Suzuki

Alto

All models: 2002 to 2007

Value displayed on coolant temperature gauge is too low.

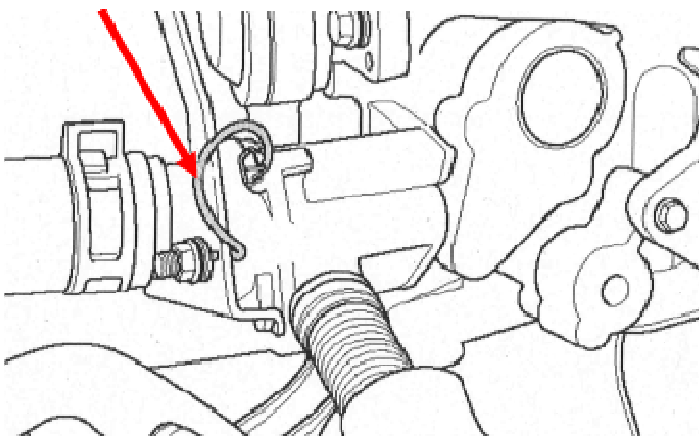
If these vehicles display an irregular coolant temperature value, the possibility of a bad ground connection to the thermostat housing bracket must be considered. To fix this problem, the ground cable (see figure) should be connected between the thermostat housing and the thermostat housing bracket.

Additionally, check the thermostat housing for damage and replace if necessary.
